ENCLOSURE 1

MFN 09-512

Response to Request For Additional Information Relating To
Amendment 31 to NEDE-24011P-A, "General Electric Standard
Application For Reload Fuel (GESTAR II),"
(TAC Number MD8425)

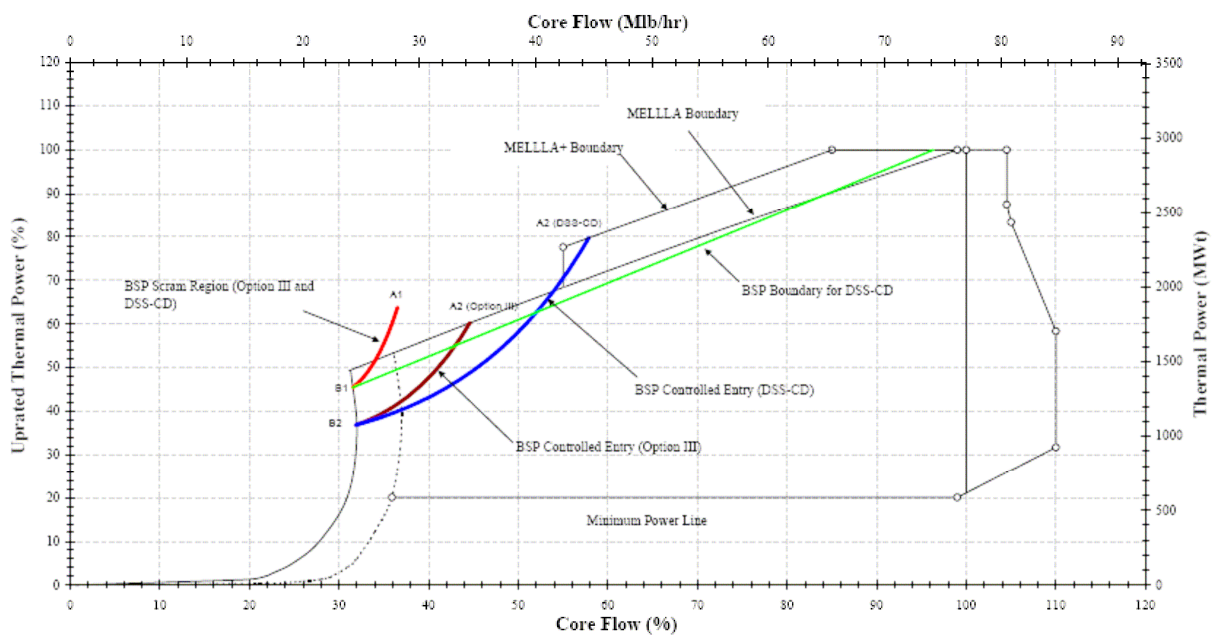
Please provide a power/flow map to show the difference of the domain for Backup Stability Protection (BSP) for DSS-CD under S.4.2.3 and Backup Stability Protection (BSP) for Option III under S.4.2.2, and describe what role Reference S-103 plays to generate a defined exclusion regions.

The calculated stability region boundaries for BSP for DSS-CD and BSP for Option III are shown in the figure below. Please note that the actual implemented BSP boundaries might be larger due to the Base BSP region definitions.

These two BSP methodologies are very similar between the two long-term stability solutions of Option III and DSS-CD. However, two differences exist:
